Reviewed for Code Compliance
Permitting and Inspections Department
Approved with Conditions

RE: 32 May St BLDR2018-00415
Response to review comments dated November 27, 2018

32 MAY ST. BATHROOM ADDITION.

Drawing : **Techno Metal Post Model P2 (Above ground light structure)**

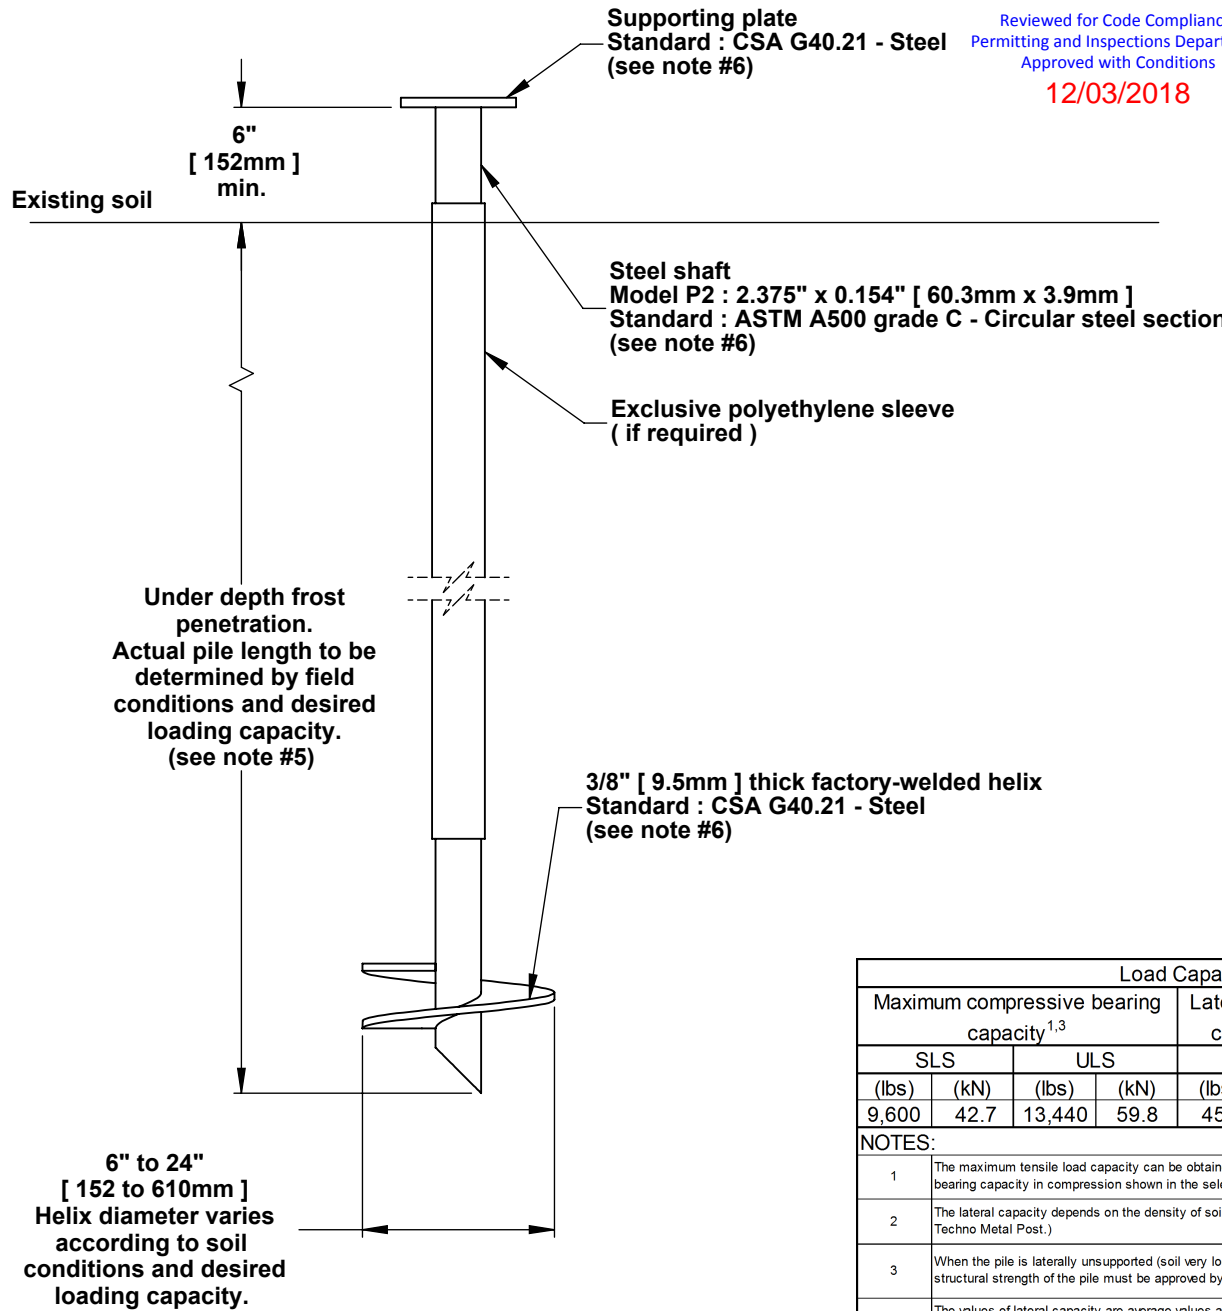
The gravity/vertical load on each of the two Techno Posts in the corners of the building is approximately 4,000# which is less than the 9,600# specified capacity for the Techno Post Model P2, which we will use for this project. Product information for the P2 post is attached.

- ROOF CONSTRUCTION:**
- ASPHALT SHINGLES
 - ICE + WATERSHIELD
 - 5/8" APA RATED SHEATHING
 - 2x8 RAFTERS @ 16" O.C.
 - MIN. 5" (R36) CLOSED CELL FOAM INSULATION BETWEEN RAFTERS
 - 2x6 CEILING JOISTS @ 16" O.C.
 - 1x FURRING @ 16" O.C.
 - 5/8" M.R. GWB OVER V.B.

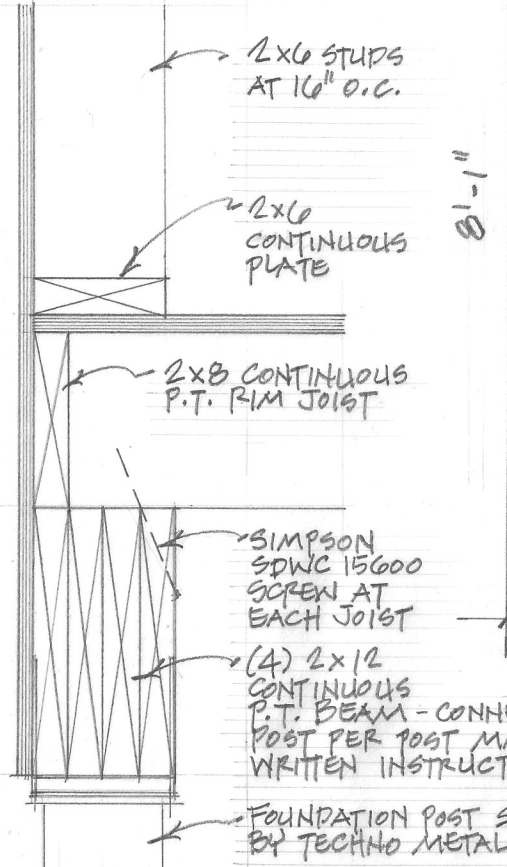
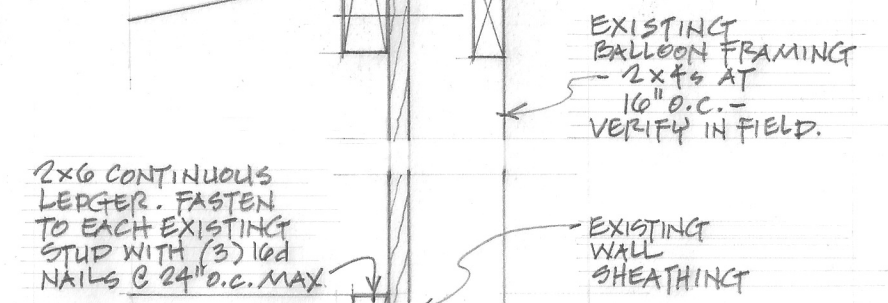
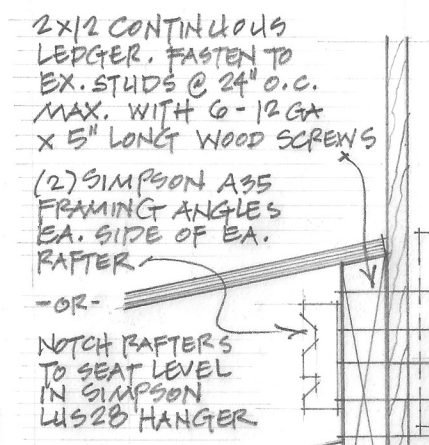
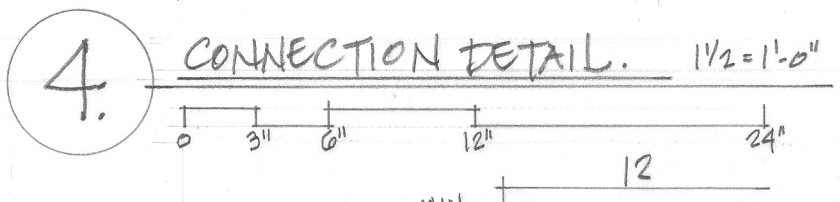
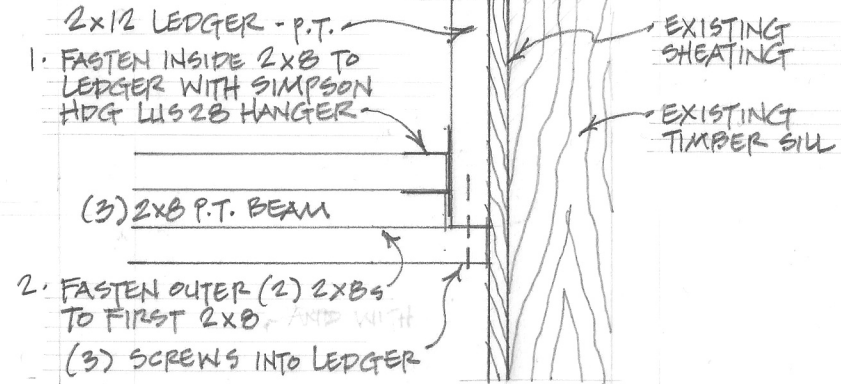
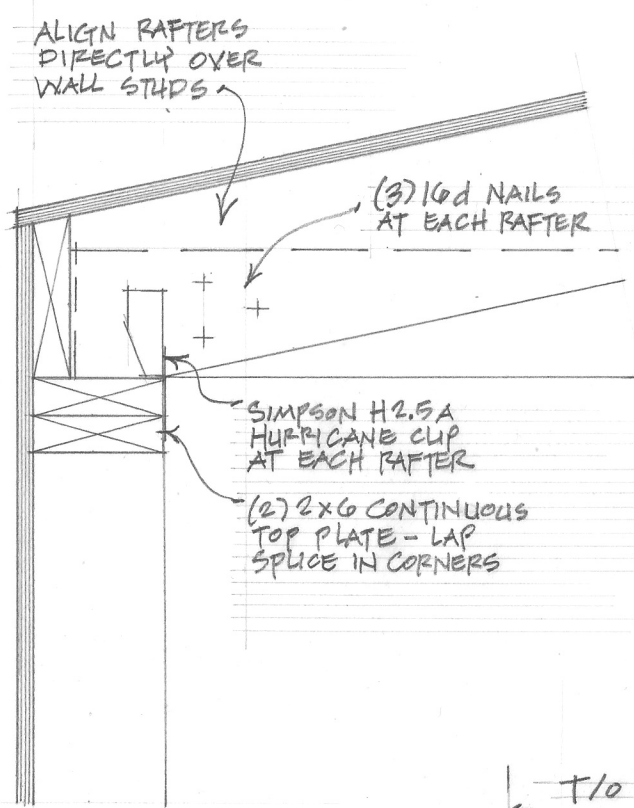
Per IECC Section 402.2.2 Ceilings without attic spaces, we may provide R-30 insulation in lieu of R-49 in the attic if both of the following bullets are met:

- There is not enough space for the required R-49 insulation. Because we are preserving the historic cornice of the original house, as preferred by historic preservation (see photo next page), attic space is limited.
- The area of the roof is below 500sf (we comply with this) or less than 20% of the total insulated ceiling area, whichever is less (we do not comply with this).

It is worth noting that in the 2015 IRC Code - Chapter 11 Energy Efficiency, a similar paragraph (N1102.2.2) does not include the maximum 20% of roof area provision. The same is true of the 2009 IRC Code that was the standard in Maine until the new codes were adopted earlier this year.

As I mentioned in our phone conversation on Friday, the owners intend to keep the door from the house to the bathroom open when the bathroom is not in use, to let light into the library. Heat will flow from the bathroom to the higher-ceilinged library. Adding more insulation to the bathroom roof will not prevent this heat flow.

I hope that you will consider these conditions and allow the reduction to R-30 insulation in the bathroom roof.

- FLOOR CONSTRUCTION:**
- TILE/STONE OVER UNDERLAYMENT
 - 3/4" APA-RATED FLOOR SHEATHING
 - 2x8 P.T. JOISTS @ 16" O.C.
 - MIN. 2" CLOSED CELL SPRAY FOAM BETWEEN JOISTS - R14.4
 - 1/2" POLYISO RIGID INSUL. R10 BELOW JOISTS
 - PROTECTION BOARD

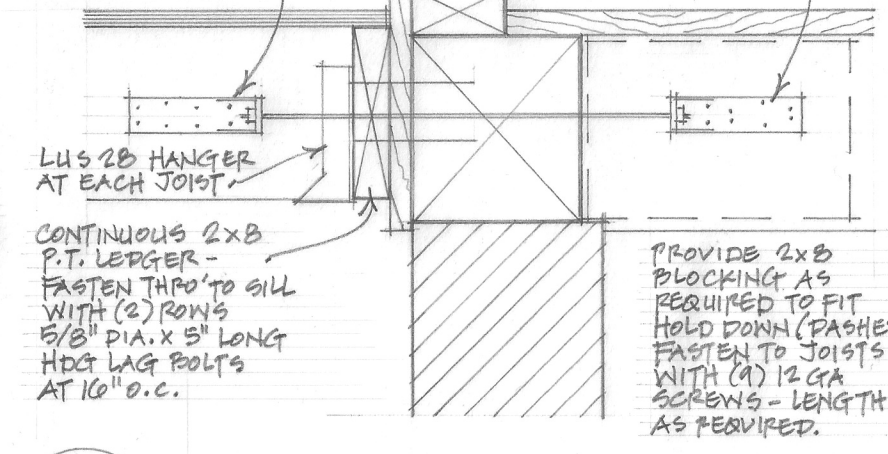
Here we are utilizing Table 402.1.2, which requires R30 insulation in the floor with the exception provided by footnote g. which states "Or insulation sufficient to fill the framing cavity, R-19 minimum." We've clearly taken some liberties here, as we are not filling the cavity because of the plumbing pipes in that space. We prefer the good seal that closed cell spray foam provides at the band joist and low in the joist bay, combined with rigid insulation boards below the joists.

Corrections to the drawings: the closed cell spray foam at 2" thick provides R-13. The rigid insulation should be 2" thick for R-10, not 1/2". Total proposed insulation R-value is R-23. If the rigid insulation is thicker, it will become impractical to install it and the protection board to the bottom of the joists as there is not a lot of clearance to grade. We are hoping that you will agree that we are doing the best we can given the existing conditions.
